Item Name: Crosstube Turning Detail

DART AEROSPACE LTD	Work Order:	95457
Description: Crosstube Assembly (205/212 High Aft)	Part Number:	D212-664-241
Inspection Dwg: D212-664-241 Rev: D		Page 1 of 2

DRAWING NO. D212-664-241	TITLE CROSSTUBE ASSY (205/212 HI AFT)	REV. D	DART AEROSPACE LTD ENGINEERING ORDER		D.E.O. NO. D212-664-241-D-1	SHEET NO. SHEET 1 OF 2	SCALE NTS
DRAWN	CHECKED	MFG. APPR.	APPROVED	DE APPR.			
DATE 11.04.07	DATE 11.04.11	DATE 11.04.12	DATE 11/04/12	DATE 11.04.12

DRAWING NO. D212-664-241	TITLE CROSSTUBE ASS'Y (205/212 HI AFT)	REV. D	DART AEROSPACE LTD ENGINEERING ORDER	D.E.O. NO. D212-664-241-D-2	SHEET NO. SHEET 1 OF 1	SCALE NTS
DRAWN 47	CHECKED ASS	MFG. APPR. [Signature]	APPROVED [Signature]	DE APPR. [Signature]		
DATE 11.07.15	DATE 11.07.20	DATE 11.07.21	DATE 11/27/21	DATE 11.07.21

D212-664-241-241B
ASSEMBLY DETAIL

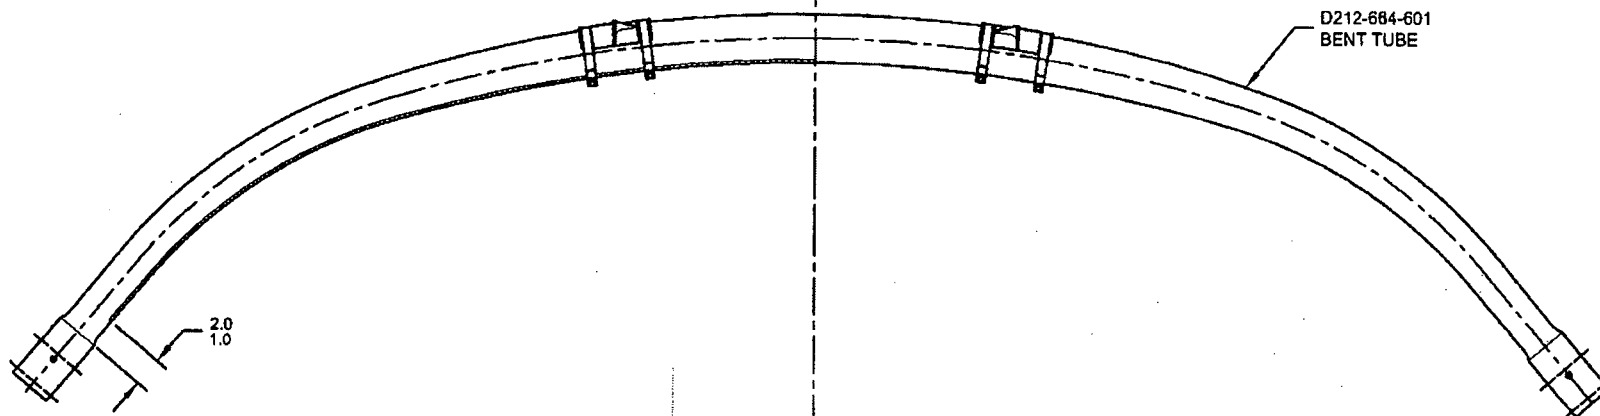
ADD AN INSPECTION WINDOW TO UNDERSIDE OF CROSSTUBE.

NOTES 2 OF SHEET 1 IS AMENDED AS FOLLOWS:

- 2) FINISH: CHEMICAL CONVERSION COAT PER DART QSI 005 4.1
PRIME INSIDE AND OUTSIDE PER DART QSI 005 4.2
MASK UNDERSIDE OF CROSSTUBE AS SHOWN (HATCHED AREA) AND
PAINT OUTSIDE PER DART QSI 005 4.2
REMOVE MASKING AND APPLY CLEAR COAT

MASK AREA PRIOR TO PAINTING,
REMOVE MASKING AFTER PAINT
AND APPLY CLEAR COAT
